## Common Area Building Survey Report

## S Aparments

The Owners Corporation  
**Strata Plan No X5YZ**

Prepared By  
**Access Property Services Pty Ltd**

Photo No 22

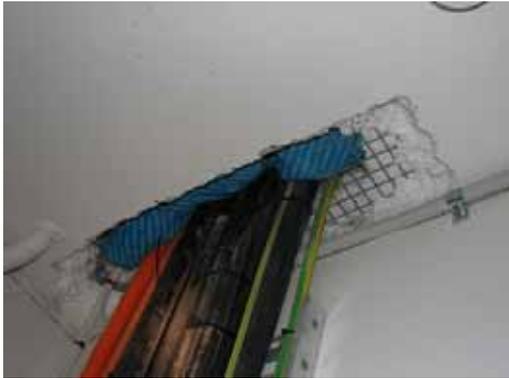
**Refer example Photo No22** of differential movement cracking in the gypsum wall plaster above fire hydrant Riser cupboard, which should be rectified.

I **recommend** rectification of noted differential movement cracking within gypsum wall plaster.
